## 69 series decoder

Version: V2.5.0

## Release Note

(2020-05-27)

#### 1. [Export abnormal information]

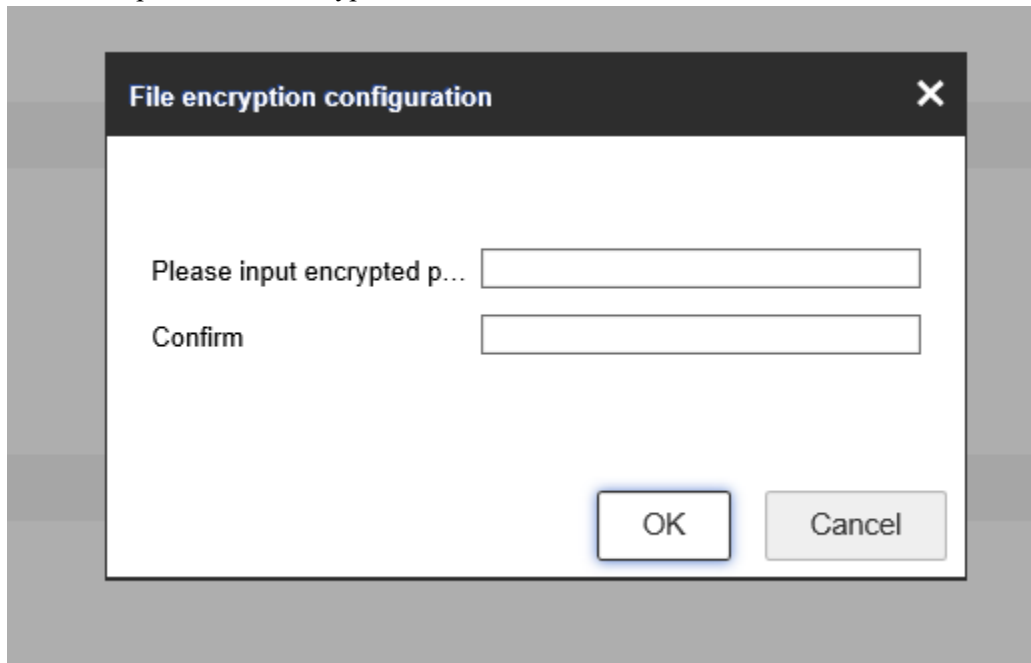
Support export diagnose log to pc on web.

You need to set password to encrypt it.
